PRODUCT CHANGE NOTICE

PCN#18-031**NOTIFICATION DATE: April 20, 2018****MODEL(S) AFFECTED:**

Existing Model:	Replacement Model:
ROS-2360W+	ROS-2360WR+

Figure 1: Frequency vs. Vtune [MHz] at. 25°C

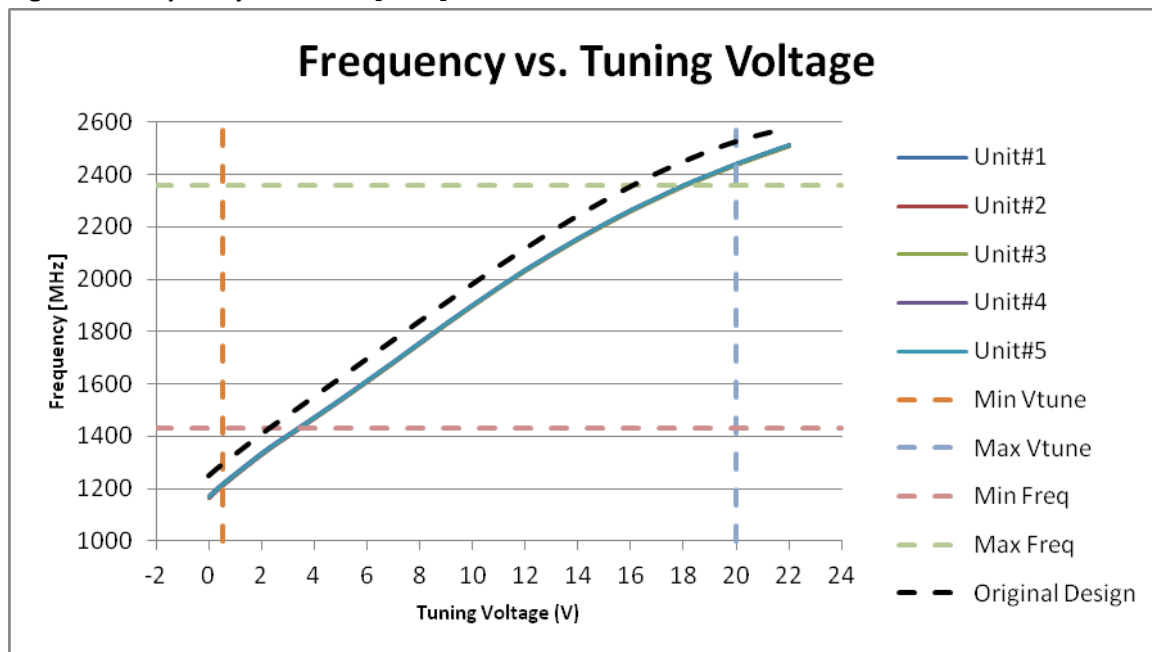
Plots of original spec and performance vs new performance attached below.

Figure 2: Sens @ Nom VCC[MHz/V] vs. Frequency [MHz] at. 25°C

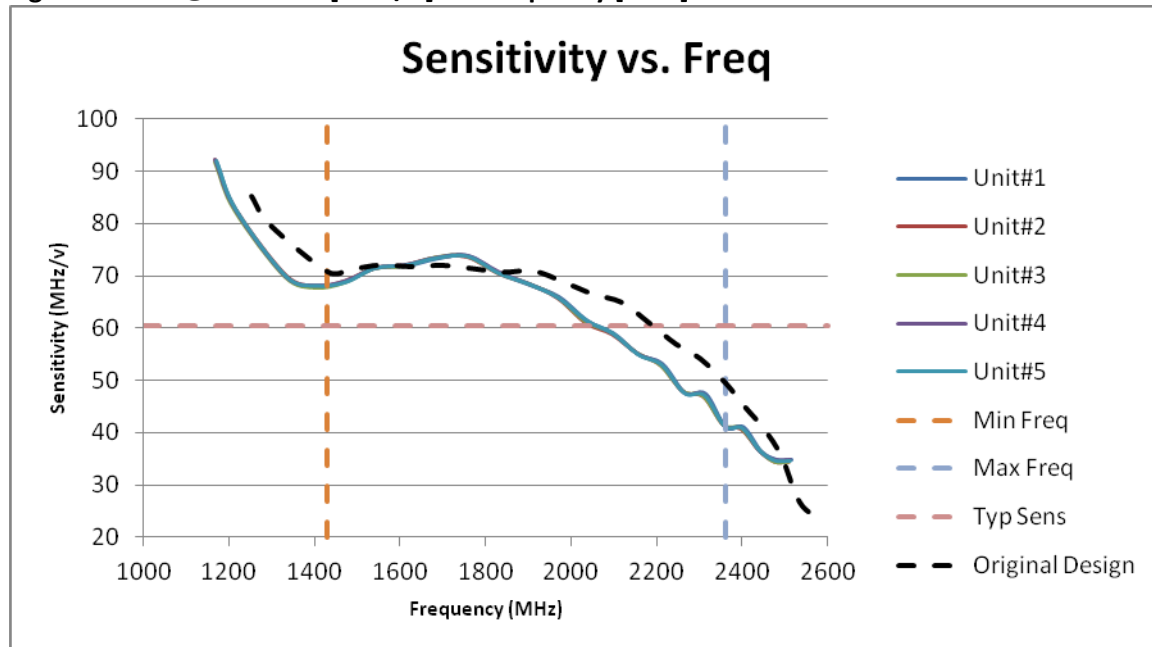
Parameters	Original Performance	Original spec	New Performance	New Spec
Sensitivity	49.6 to 72.1 MHz/V	51-70 MHz/V Typ	41 to 73.9 MHz/V	41-74 MHz/V Typ
2 nd Harmonic	-33.14 to -15.95 dBc	-20 dBc Typ	-25.45 to -12.51 dBc	-19 dBc Typ
3 rd Harmonic	-35.33 to -18.02 dBc	-10 dBc Max	-39.84 to -26.09 dBc
